Control Message Update v2

Dave Olsen 7/19/2012

Control Stream Format

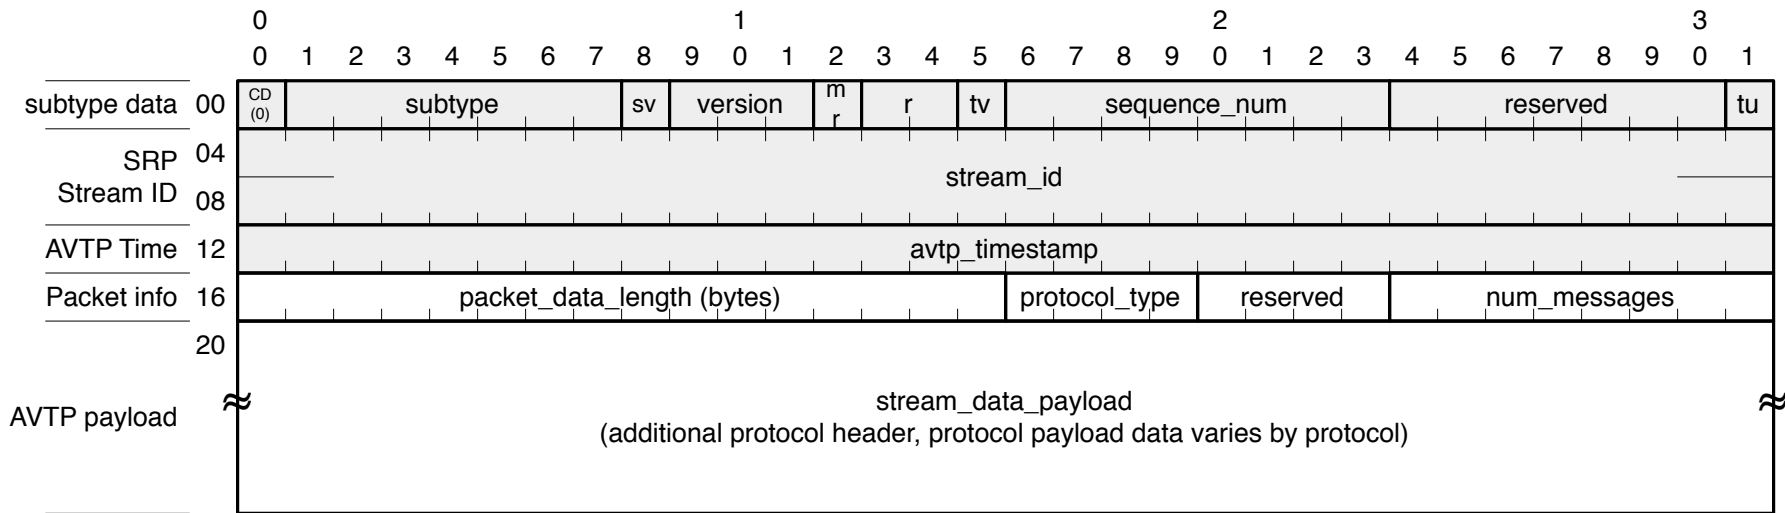
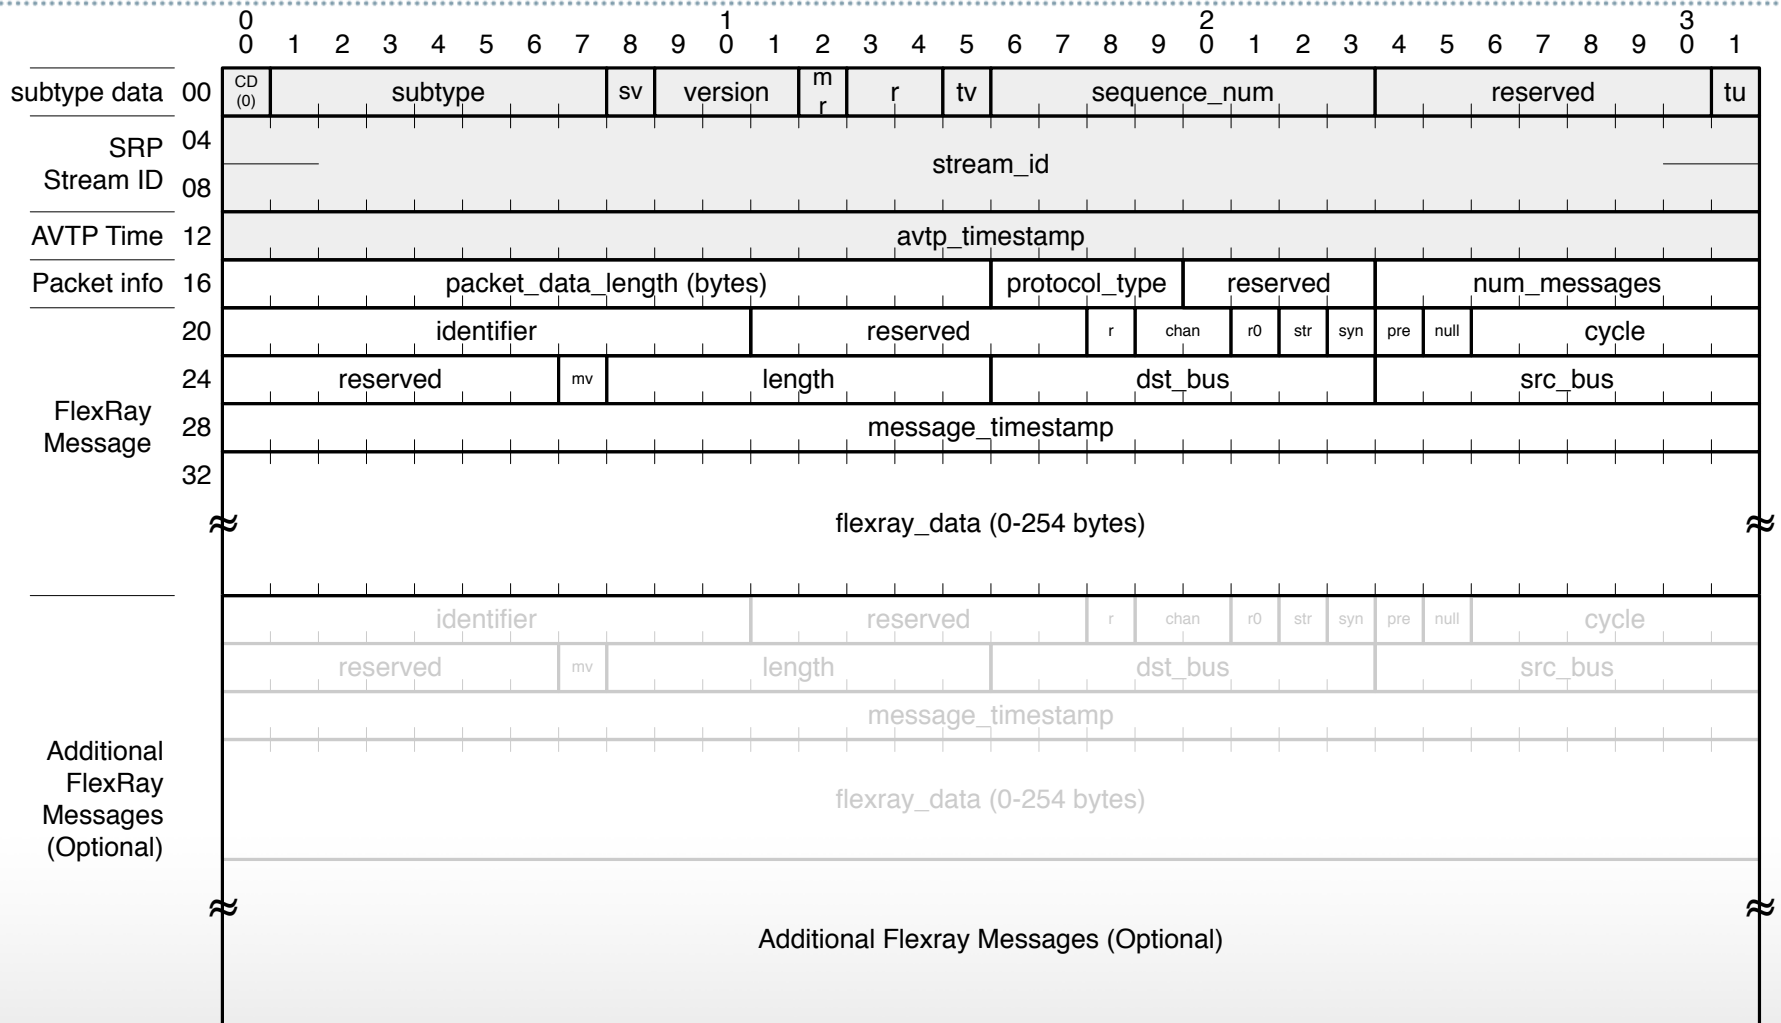
-
- **Source and Destination Bus fields change to 8 bits**
 - **Timestamp per message**
 - **Normalize Length fields**

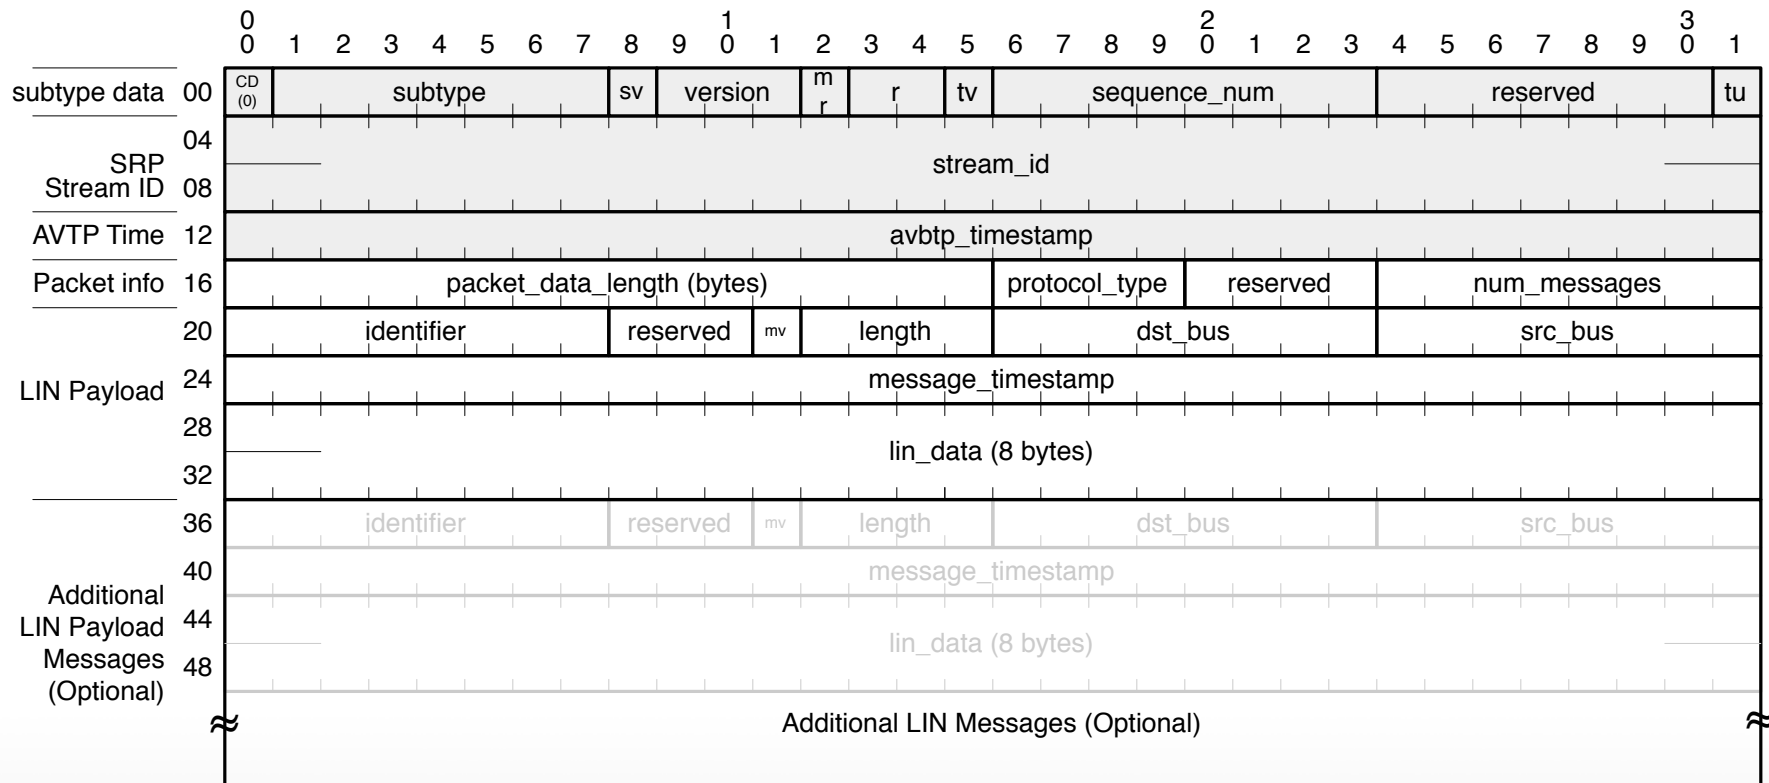
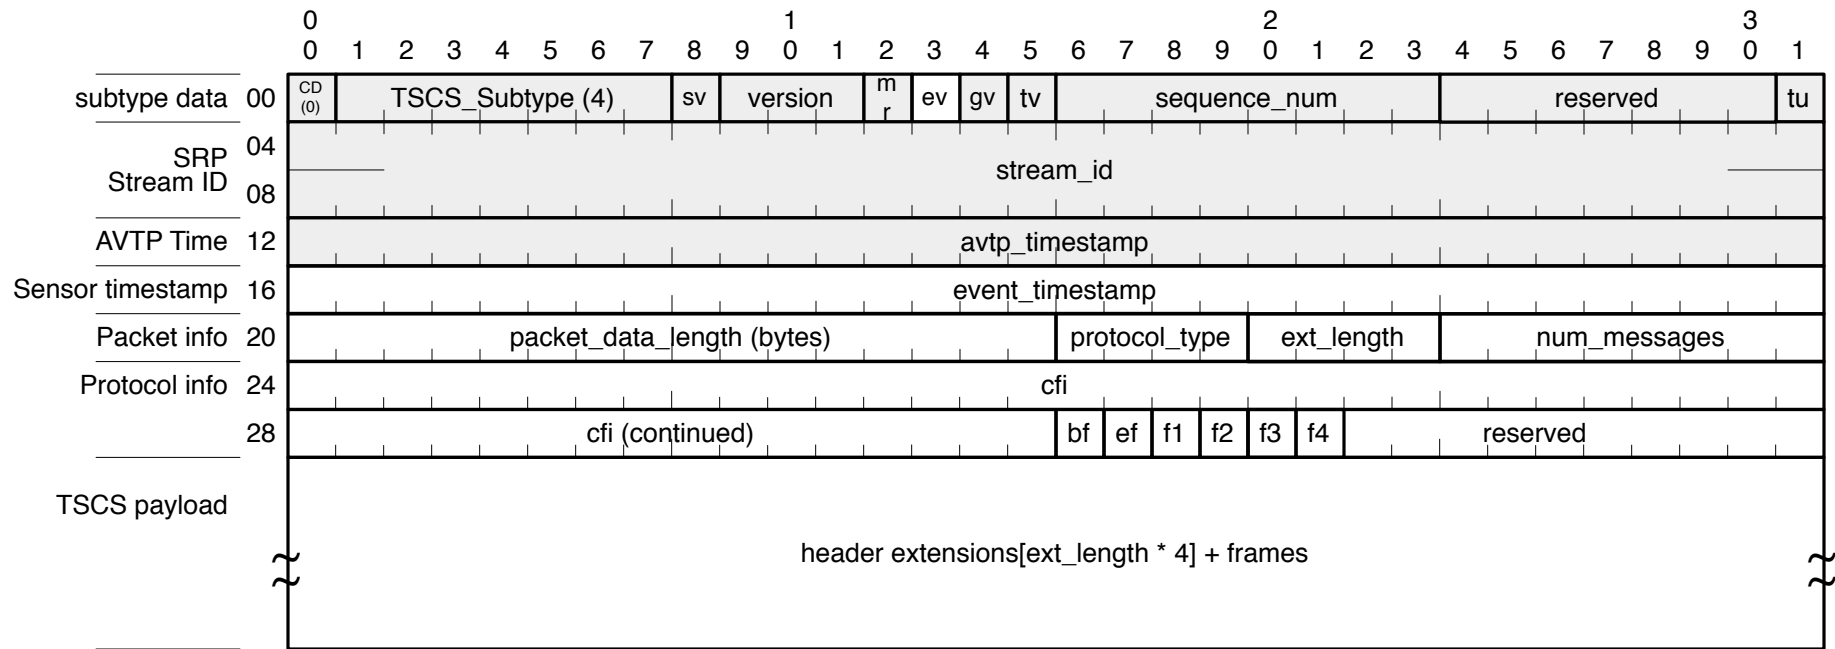
-
- **Remove event timestamp from TSCS messages**
 - **Do not add a message timestamp to the TSCS, this puts us back where we started with the TSCS messages.**
